## **Report – Capital Expenditure Victorian Electricity Distribution Revenue Review Revised Proposals**

**A report to the AER**

**26 October 2010**

**Figure 17 - CitiPower IT capex**

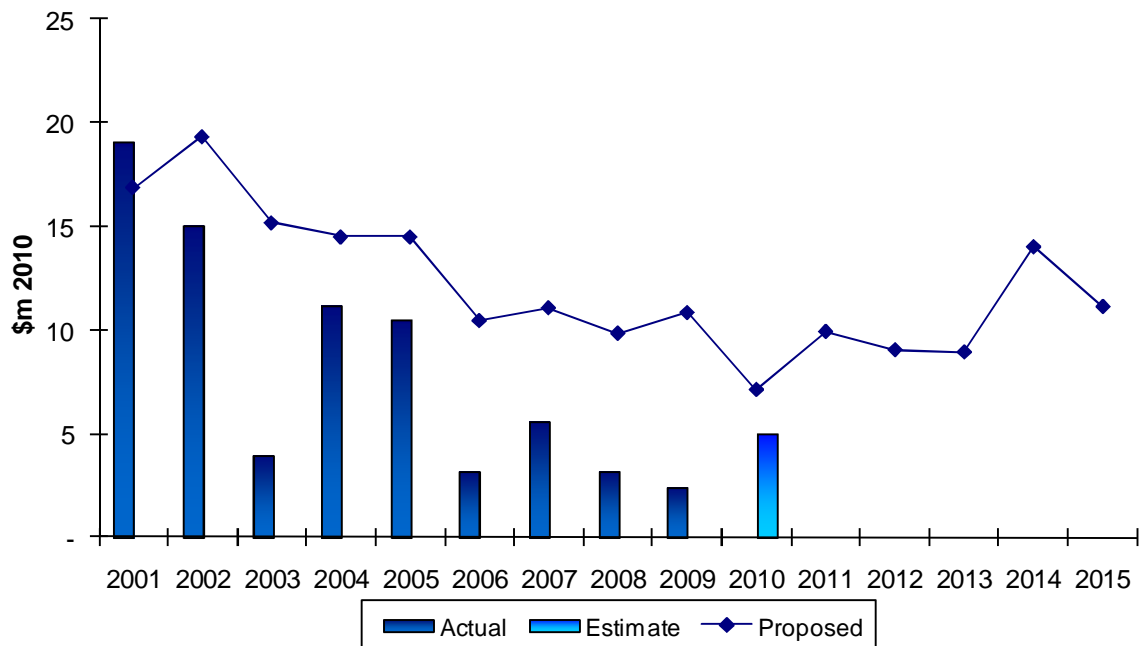
In their revised proposal, CitiPower re-submitted IT capital expenditure of \$53 million over the forthcoming regulatory control period, which represents an increase of 196% in average annual capital expenditure from that actually incurred in the current period. Major proposed IT capital projects include CIS replacement, leveraging off the AMI project and increasing the utilisation of mobile computing in the field.

CitiPower and Powercor are related parties and each holds a separate electricity distribution licence for a defined geographical electricity distribution area in Victoria. The Distribution Networks are jointly managed and operated by Powercor Australia and CitiPower personnel and systems. Under the Cost Sharing Agreement, defined overhead costs incurred by Powercor Australia and CitiPower are apportioned between each respective business. CHED Services provides both CitiPower and Powercor with specialist corporate services including: the Chief Executive Officer; Finance; the Company Secretary and Legal; Human Resources; Corporate Affairs; Regulation; Customer Services; Information Technology; and Office Administration; and under the Metering Services Agreement a number of metering services. To assist us with the analysis, we again combined the CitiPower and Powercor submissions to review the actual proposed costs.

**Figure 21 RQM expenditure increase**

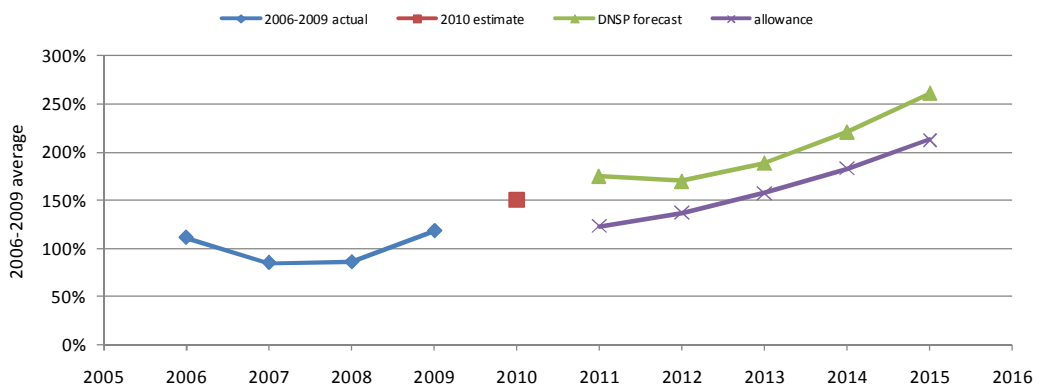
Given the scale of these increases, we consider that Jemena would need to provide detailed reliability and economic analysis to justify its proposal. We have not been provided with such modelling. On this point, we do not disagree that the programs may realise the benefits discussed in the strategic papers. However, we do not consider that, in light of the above, the analysis in these papers clearly justifies that they need to be funded purely to maintain reliability, rather than funded through the reliability incentive scheme.

**Figure 32 RQM expenditure increase**

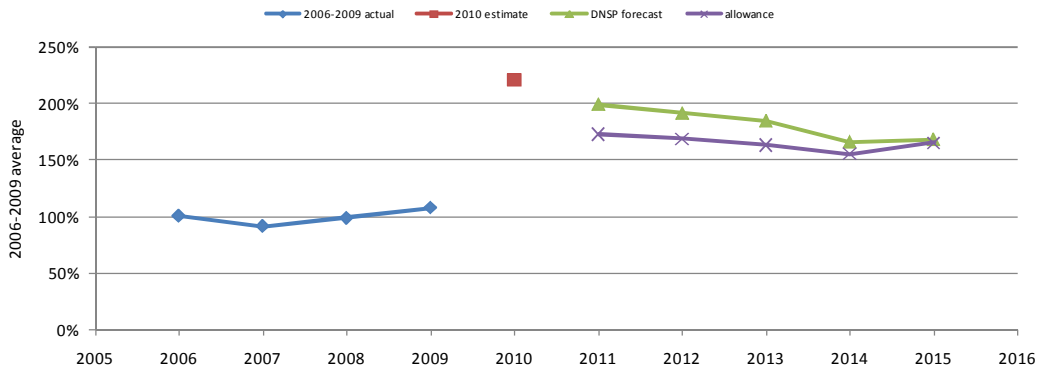
Given the scale of these increases, we consider that United Energy would need to provide detailed reliability and economic analysis to justify its proposal. We have not been provided with such modelling. On this point, we do not disagree that the programs may realise the benefits discussed in the strategic papers. However, we do not consider that, in light of the above, the analysis in these papers clearly justifies that they need to be funded purely to maintain reliability, rather than funded through the reliability incentive scheme.

**Figure 36 - 2004 Weighted Average Remaining Life projection**

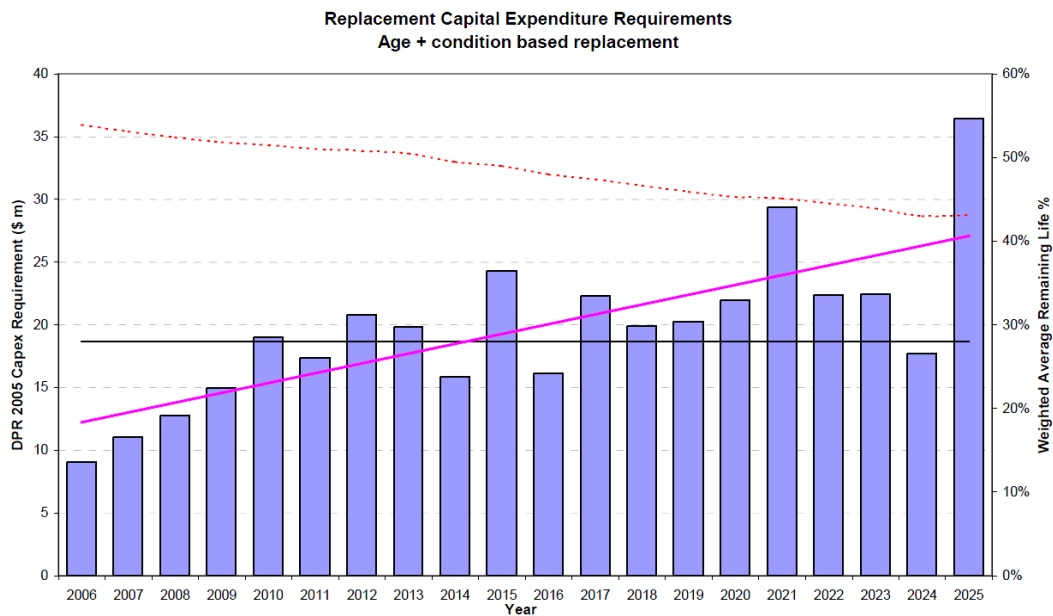
In the 2004 submission, AGL, the then owners of the Jemena franchise area, highlighted aging assets as a significant contributor to a requirement for increased capex<sup>332</sup>. The following chart highlights the proposed capex increases and the aging assets. The proposed capex increase is highlighted in blue and the aging assets via the “Weighted Average Remaining Life (WARL) in dotted red.
